FORMER SPERRY REMINGTON SITE (NYSDEC SITE I.D. #808043)

REVISED INTERIM REMEDIAL MEASURE WORK PLAN

Project Number MN0832A
Document Number MD19202

**Re: Revised Interim Remedial Measures Work Plan
Former Sperry Remington Site #808043
Elmira, Chemung County**

Proposed Shallow Soil Removal

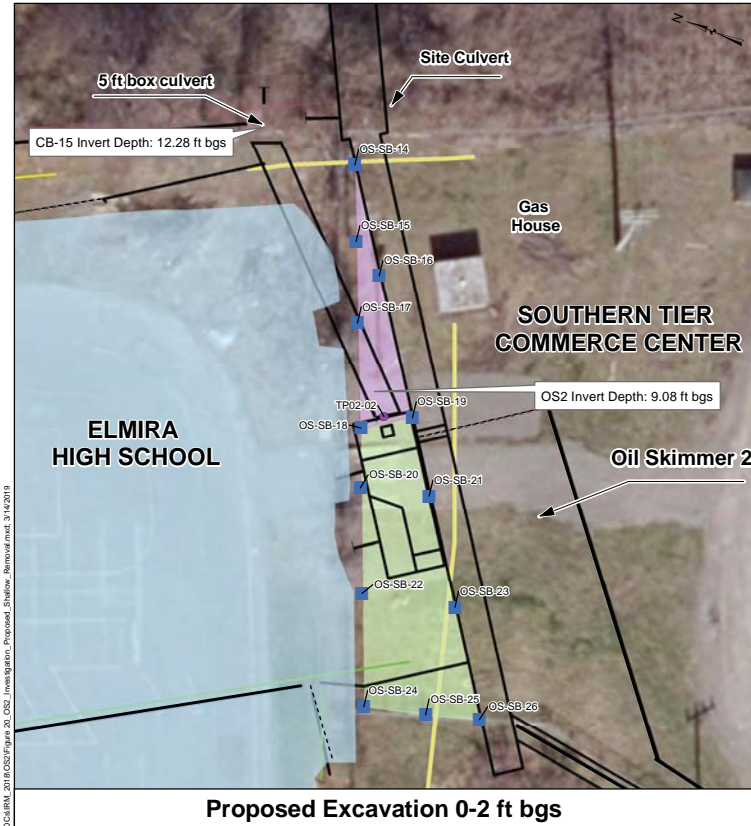
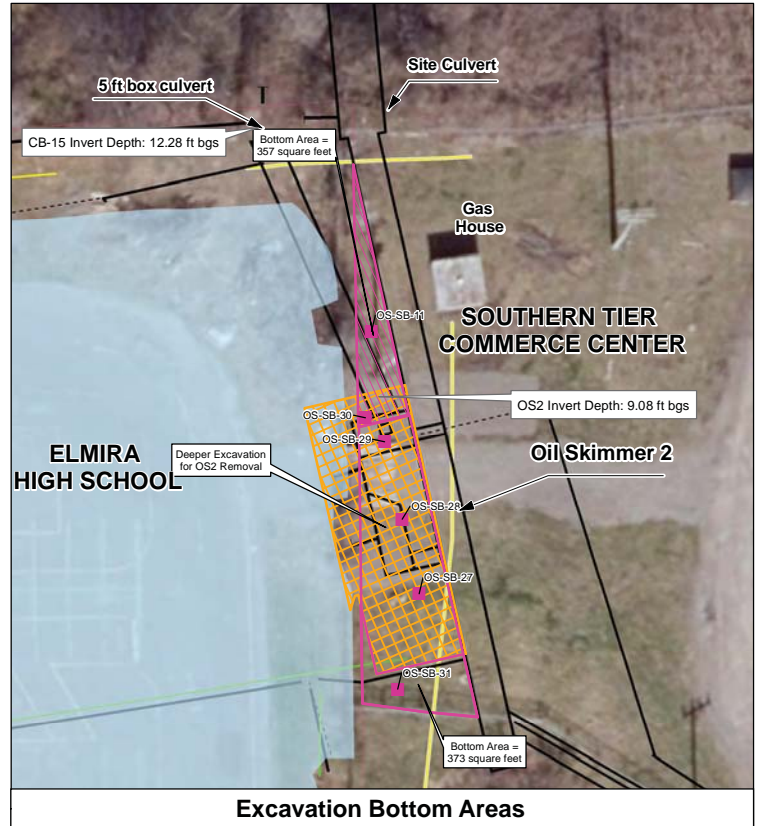
32. *Figure 20 – the proposed excavation 0-2 ft bgs should depict the extent of slope benching necessary to remove OS-2.*

Response: Figure 20 presents the proposed shallow soil excavation to achieve the IRM objectives for soil cleanup at the Site. Sloping of the excavation to remove OS2 will extend onto the EHS property. Soils on the 0-2 ft interval have been previously remediated on that property as part of IRM #2 for the Former Sperry Remington Site – North Portion (#c808022).

DATE:	NOVEMBER 2018
PROJECT NO.	MN0832A
DOCUMENT NO.	MD18229
FILE NO.	0832f002
FIGURE NO.	21

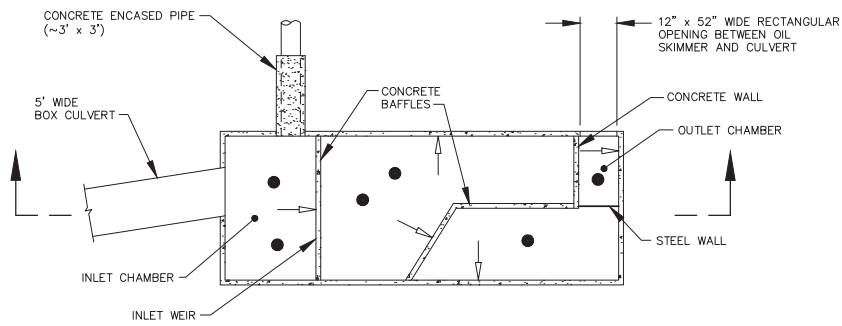
33. *Figure 21 – 3" steel pipes on north edge of OS-2 do not exist.*

Response: The steel pipes have been removed from Figure 21.
